# SERVICE BULLETIN

Bulletin Part Number: 296133-B3

**Product:** L1® Model II and L1® Model 1S Systems

**Subject:** Wiring harness heat shrink sleeve damaged through chafing. Wiring harnesses slipping off of retaining posts due to not being glued in place.

Figure 1

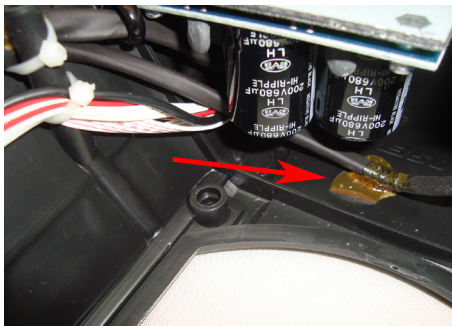
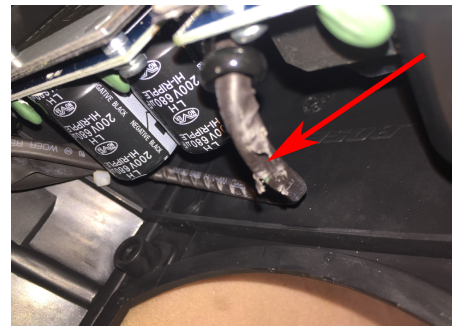
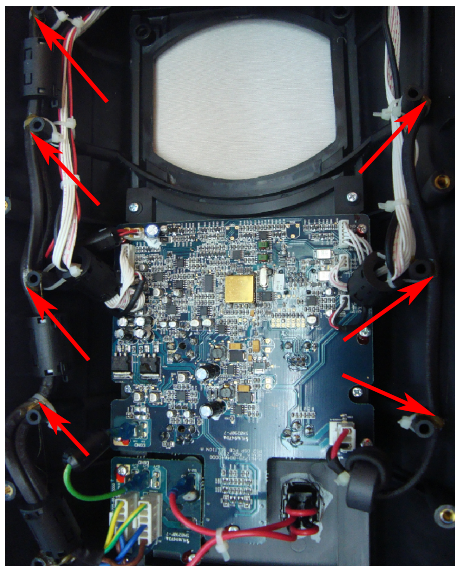
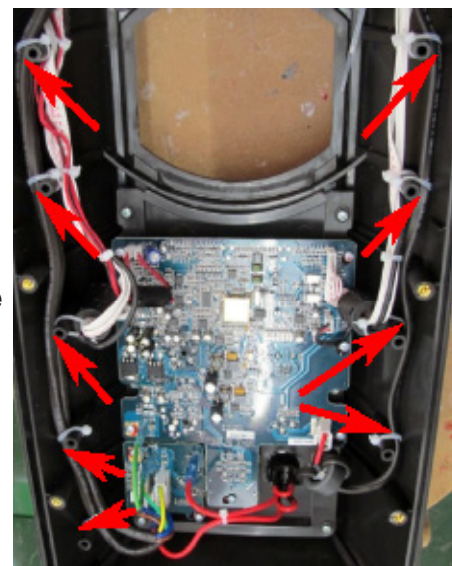
**Symptom:** The internal power cable near the array cavity may be damaged by the leg assembly, due to chafing. In addition, the tie wraps that hold the wiring harnesses in place along the sides of the cabinet were not glued, resulting in them slipping off the retaining posts.

**Reason:** Vendor process eliminated glue between above DOM range dates. Result is that the cable tie that holds the harness to the plastic pole can slip off the post.

**Solution:** Remove the leg assembly. Refer to service manual for disassembly instructions. Inspect the harness cable for any defective or loose cable ties. Replace any defective cable ties and apply RTV glue to secure the tie wrap to the post. Use RTV glue to secure the harness to the case beneath SMPS as shown in Figure 1.
